ENGINE - HP TURBINE ROTOR AND STATOR ASSEMBLY - PROVIDE NEW STAGE 1 HPT VANE PLATFORM
SEALS - CATEGORY CODE 7 - MOD.ENG-72-0151

V2500-ENG-72-0151

Location of the Stage 1 HPT Seal
Fig.1

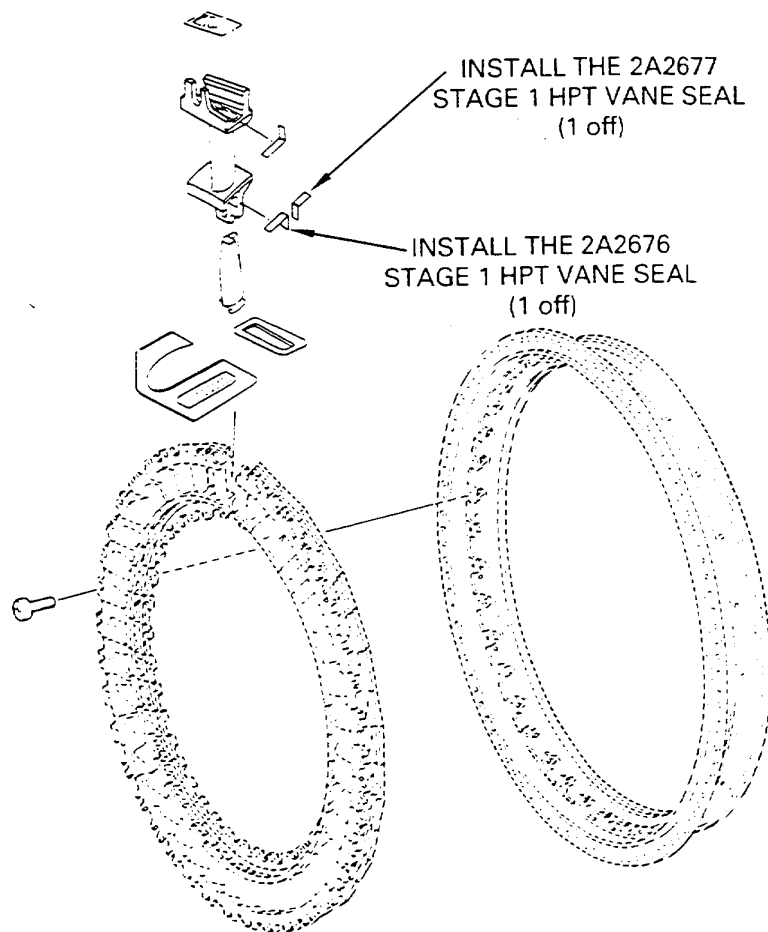
The two "L" shaped interlocking seals are replaced with two individual seals.

- (1) Provide new Stage 1 HPT Vane Platform Seals.

- (1) For V2500-A5 Engines
 - (a) Install the 2A2676 Stage 1 HPT Vane Seal (1 off) and the 2A2677 Stage 1 HPT Vane Seal (1 off) at 40 locations, when you install the HPT Vane Cluster Assemblies by the procedure given Reference (2), Chapter/Section 72-44-00, Assembly, and Figure 1.
- (2) For V2500-D5 Engines
 - (a) Install the 2A2676 Stage 1 HPT Vane Seal (1 off) and the 2A2677 Stage 1 HPT Vane Seal (1 off) at 40 locations, when you install the HPT Vane Cluster Assemblies by the procedure given in Reference (3), Chapter/Section 72-44-00, Assembly, and Figure 1.
